SERVICE BULLETIN

TITLE : AIR CONDITIONING - INTRODUCE SOME IMPROVEMENTS TO AVOID WATER
CONDENSATION IN THE COCKPIT.

SERVICE BULLETIN No. : A320-21-1902

REVISION No. : 1 - Feb 18/92

Apply Self-Adhesive Foam Pieces on Left Lining in Cockpit
Figure 1 Sheet 1 of 3

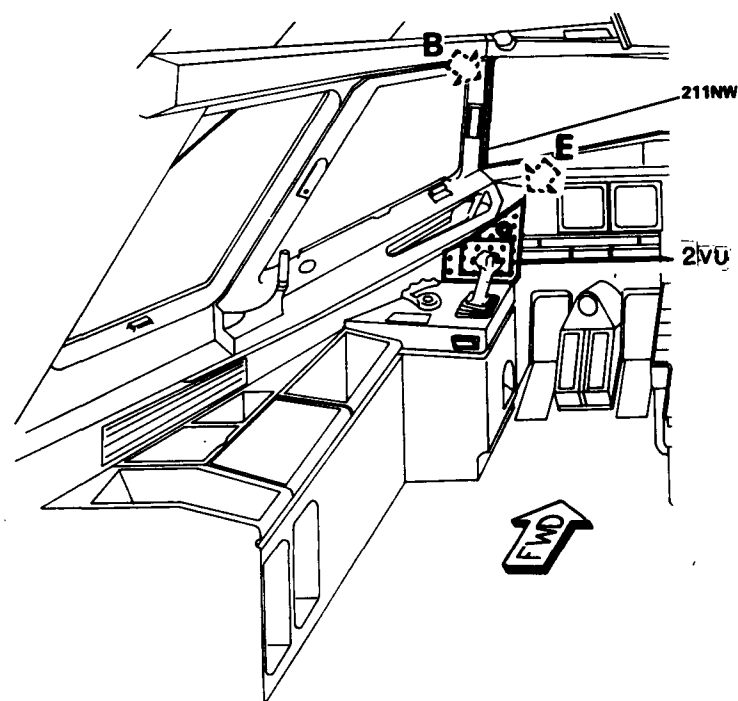
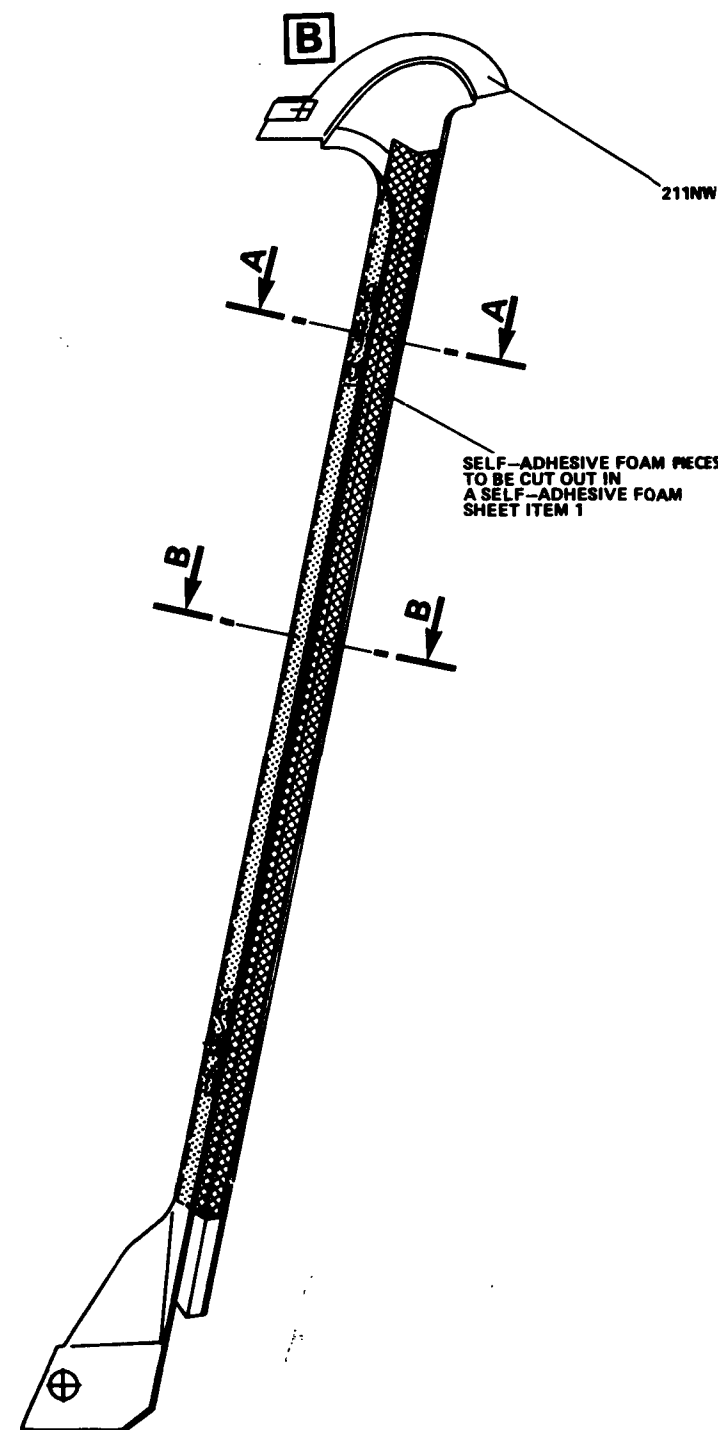
Refer to figure 1 sheet 1 of 3, 2 and 3

- (a) Cut-out 6 pieces of self-adhesive foam as per shop sketches No. C 000075, C 000076, C 000077 and figure 1 sheet 3.

- (b) On lining panels 211NW, 211PW, 8DG1 and 2VU apply self-adhesive foam pieces as per shop sketches No. C 000075, C 000076, C 000077 and figure 1 sheet 3.

**Gaps to be Sealed on Lower and Upper Left Lateral Frames in the Cockpit
Figure 2 Sheet 1 of 3**

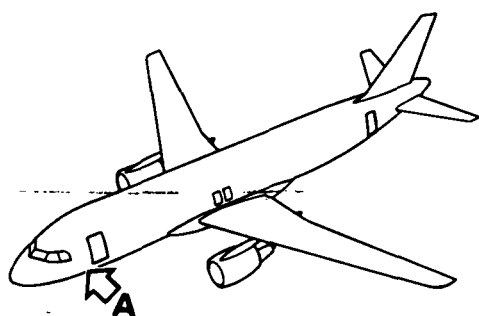
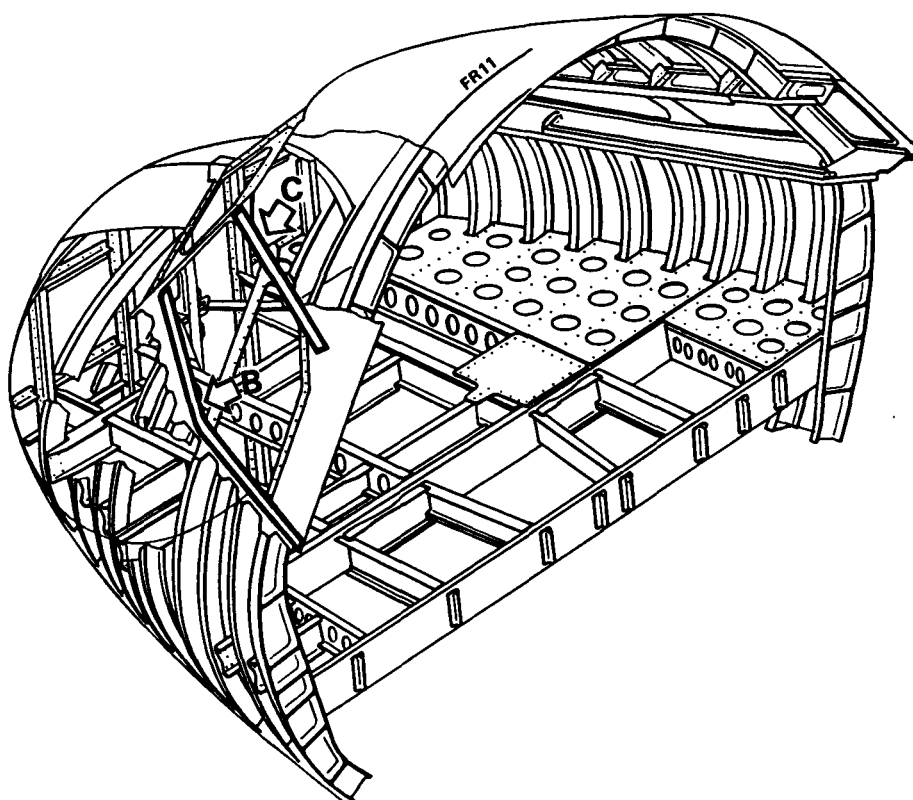
Refer to figure 2 sheet 1 of 3, 2 and 3.

- (a) Before sealing gaps, blank off bottom gaps using adhesive tape Mat. No. 05-015.
- (b) With a brush, apply a coat of release agent Mat. No. 05-013 and let dry.
- (c) Seal gaps using sealing compound Mat. No. 09-019.
- (d) After drying of sealing compound, remove the adhesive tape.

Gaps to be Sealed on Lower and Upper Left Lateral Frames in the Cockpit
Figure 2 Sheet 2

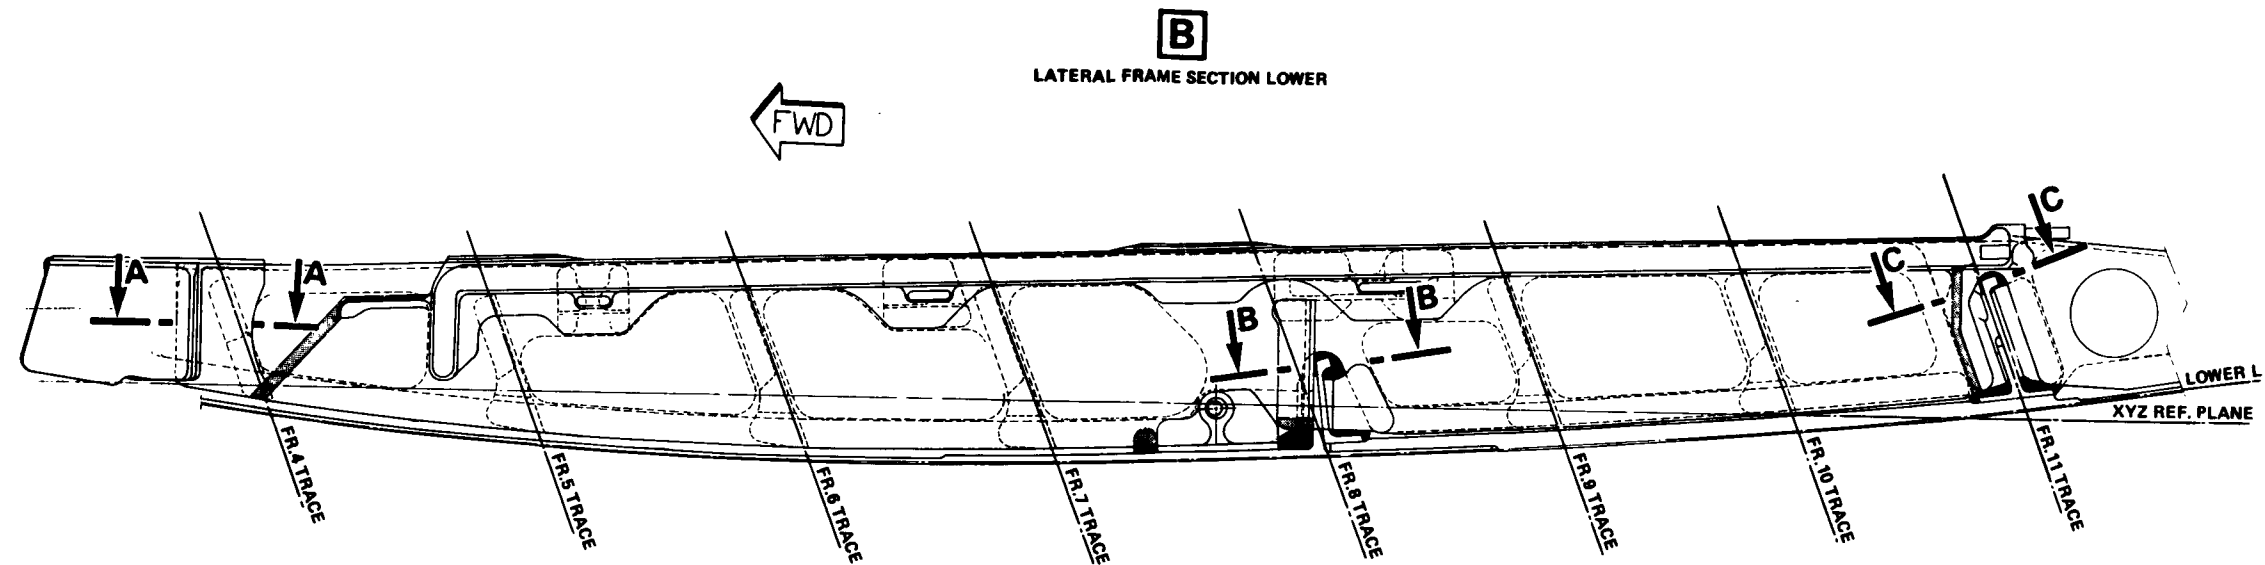
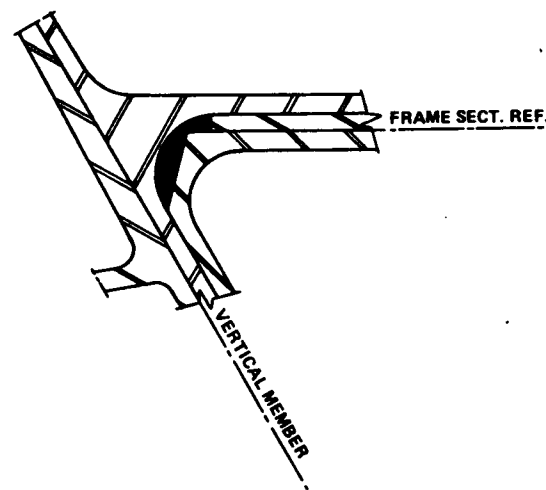
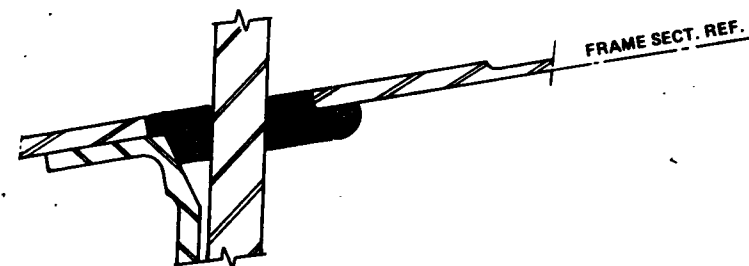
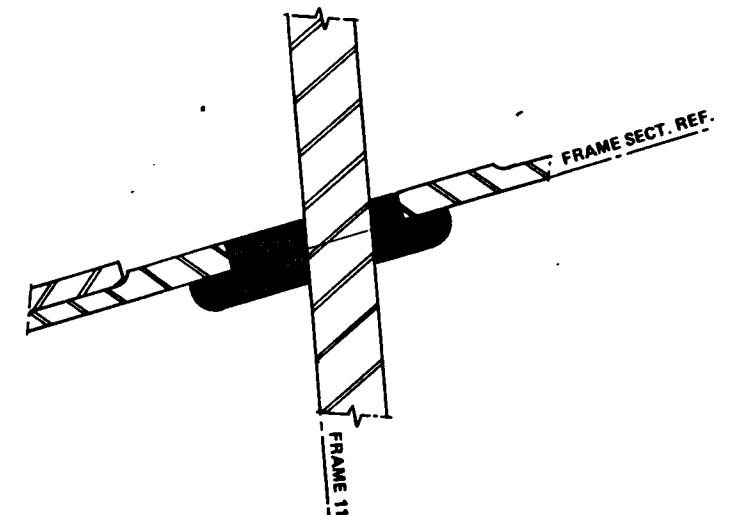
GAPS TO BE SEALED WITH MAT. No. 09 - 019
AND MAT. No. 05 - 013

Gaps to be Sealed on Lower and Upper Left Lateral Frames in the Cockpit
Figure 2 Sheet 3

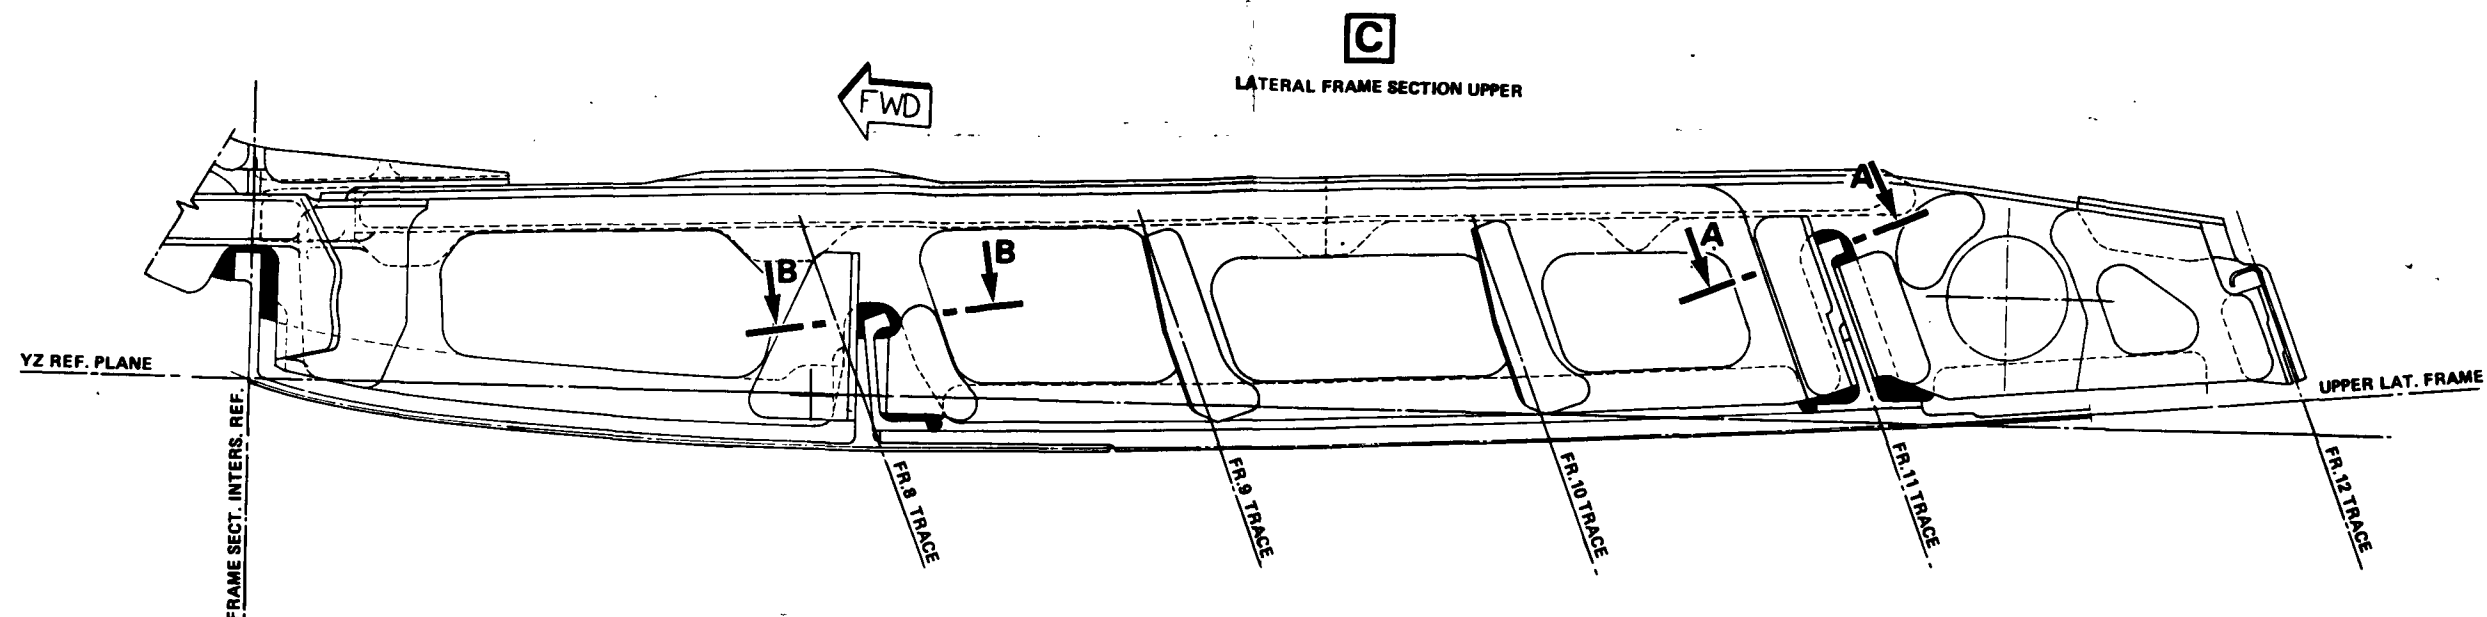
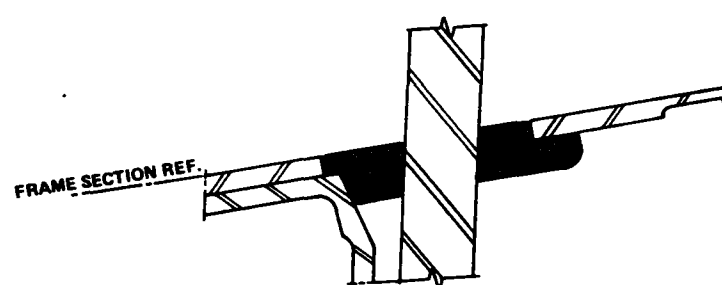
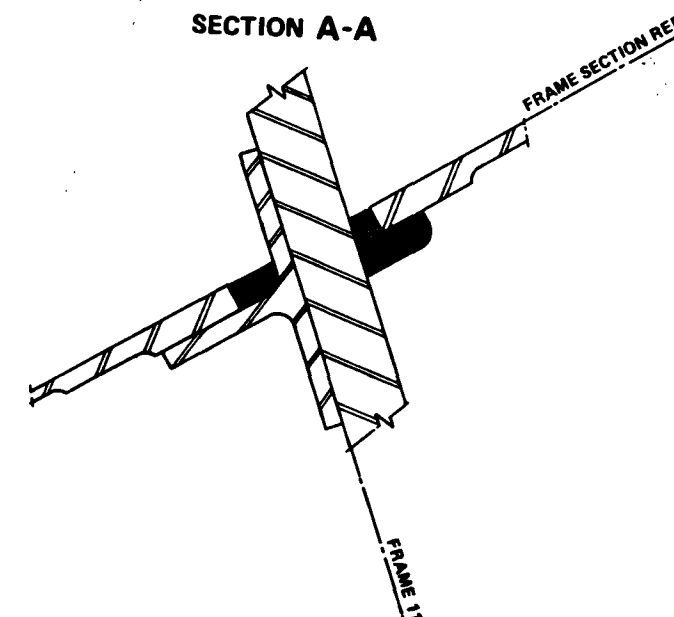
GAPS TO BE SEALED WITH MAT. No. 09 - 019
AND MAT. No. 05 - 013
